Addendum No. 4

DATE: September 2, 2009

PROJECT #: Marshall Street Elementary School
Paterson, NJ
SDA Contract #PA-0006-C03

The following revisions to the Bid Documents by Addendum #4 are:

10 VENTILATION SYSTEM
R-1 DETAIL

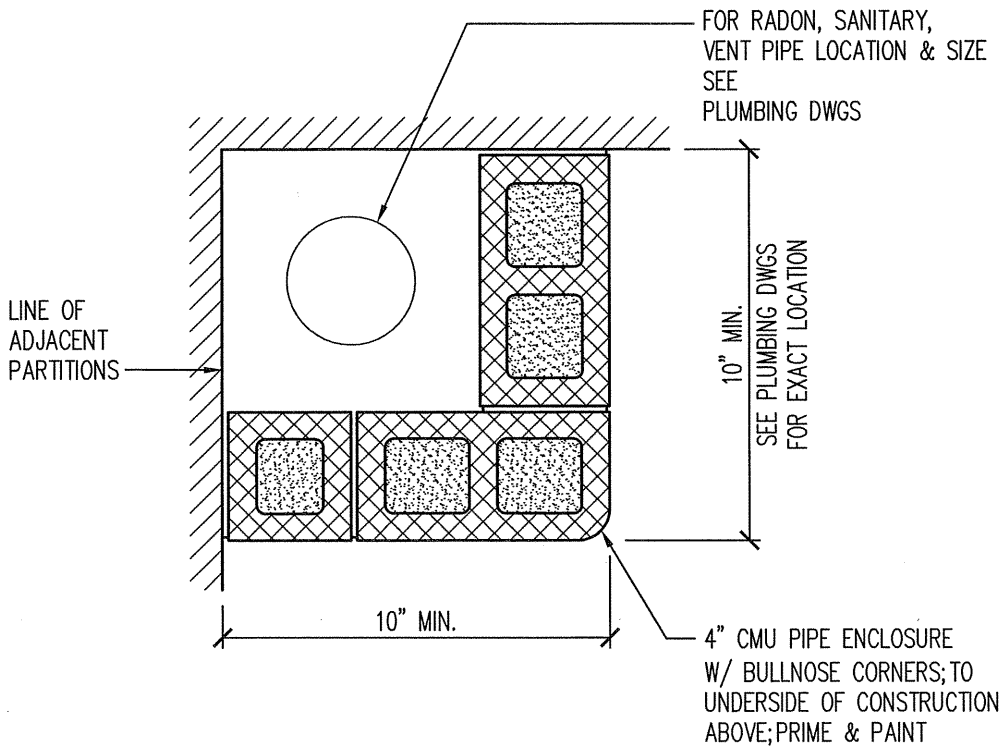
8. REPLACE detail 10 on Drawing R-1 (Addendum #1) with the attached Figure No. 1 "Fig R-1, Detail 10 revision" dated 9/3/09.

Dwg. No.:
SKA-4
ADDENDUM #4

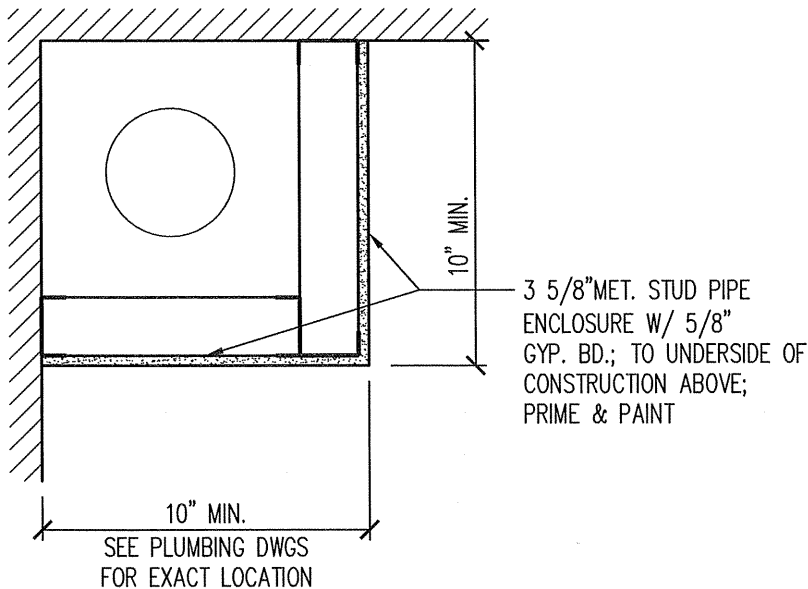
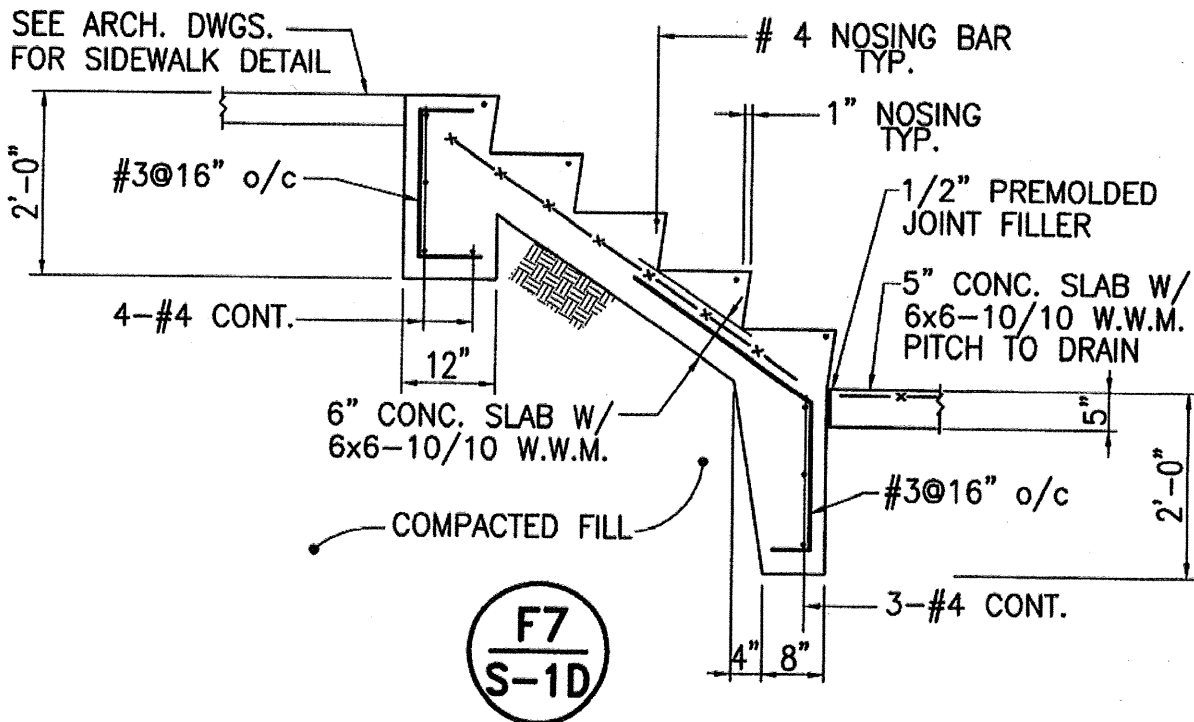
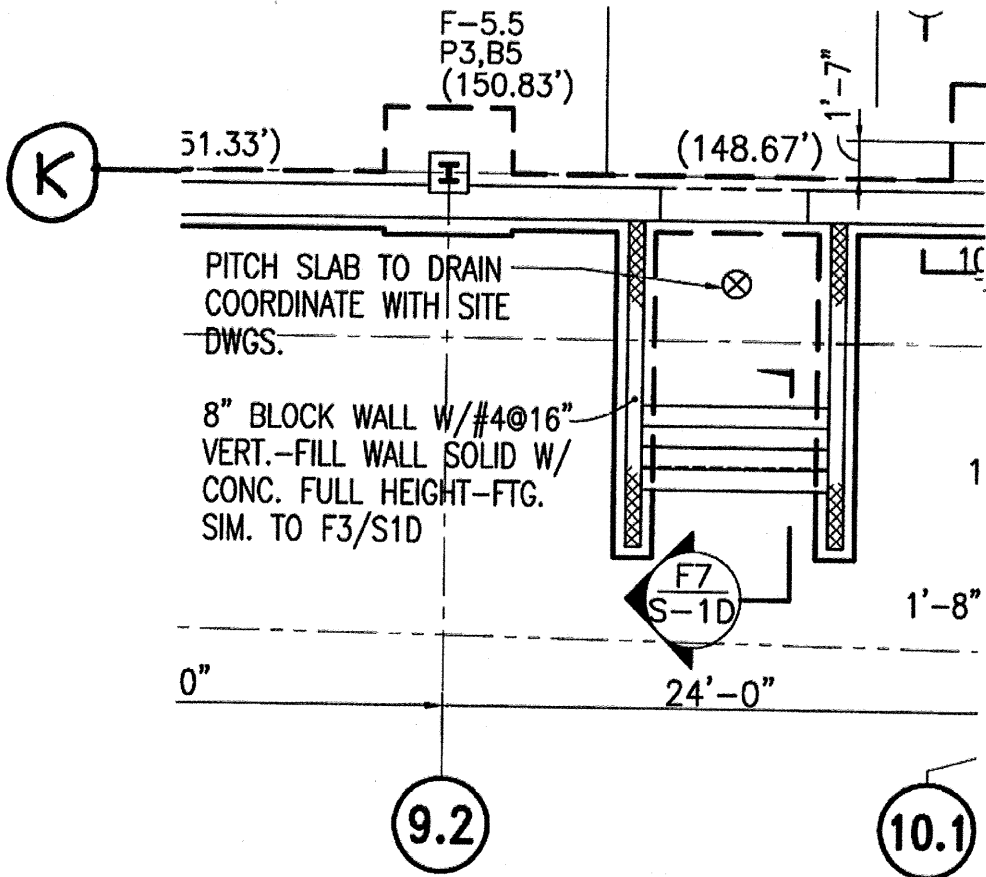
4. REPLACE the Sketch SKA-4 previously issued in Addendum #3 with the enclosed SKA-4 dated 9/1/09, Typical Vertical Pipe Enclosure Detail. This detail is to be used for all exposed vertical piping depending on the adjacent construction type.

Dwg. No.:
SKS-4
ADDENDUM #4

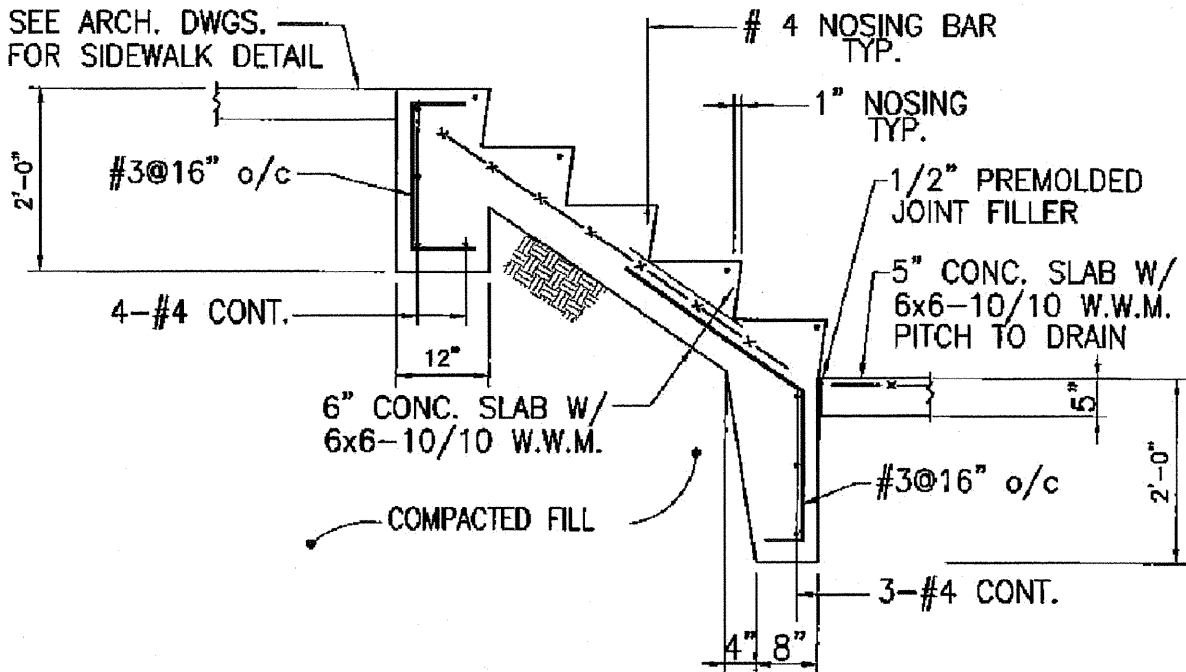
5. ADD Sketch SKS-4: Concrete Stair Reinforcing at Gymnasium.
6. ADD Sketch SKS-5: Typical concrete stair/retaining wall reinforcing detail.
7. DELETE Sketch SKA-5. Refer to Specification Section 02791 Playground Protective Surfacing. Delete reference to "Detail A" on Drawing 11/A-06.
